Subject: Limerick Generating Station, Unit 1  
Relief Request for the Corrosion Monitoring  
System for Residual Heat Removal Heat Exchanger

## RELIEF REQUEST NO. RR-16

Schematic Diagram Of Corrosion Monitoring System, Loop 'B'

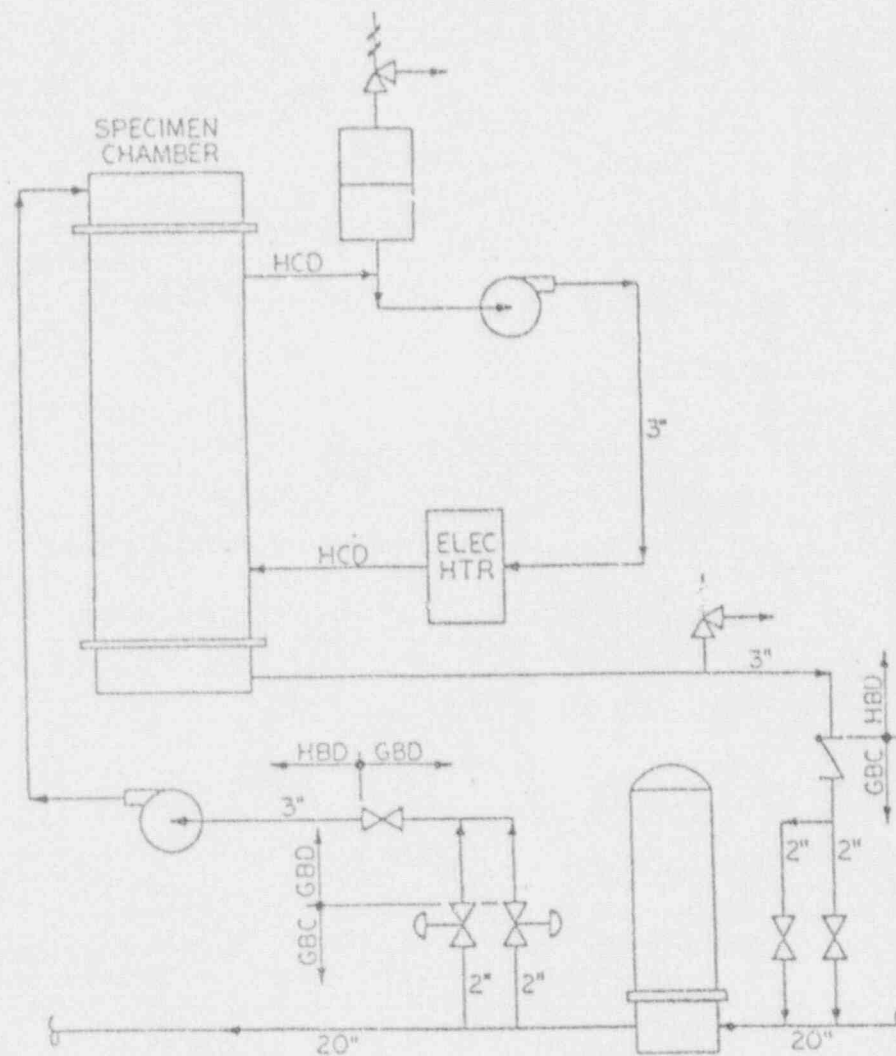
ASME Code required material will be used for the portions of the inlet and outlet piping of the corrosion monitoring system directly connected to the RHRSW system, extending to single valves capable of automatic closure. Material availability precluded the ability to purchase a second ASME Code, Section III, Class 3 valve for the inlet and outlet lines.

The inlet isolation valves will automatically close when the pressure inside the monitoring system exceeds a predetermined value based on a postulated RHR heat exchanger tube rupture, or on loss of air and/or power to the valve operators. The outlet lines are provided with check valves which will also close as a result of reverse differential pressure between the corrosion monitor and the RHR heat exchanger.

The high pressure actuation signal, however, will not be Class 1E qualified, since the pressure separation function served by these valves is not safety-related. Additionally, commercial grade manual isolation valves will be provided to allow for isolation between high and low pressure piping classes. Also the low pressure piping will be provided with a safety relief valve sized to handle the design basis RHR heat exchanger tube leakage.
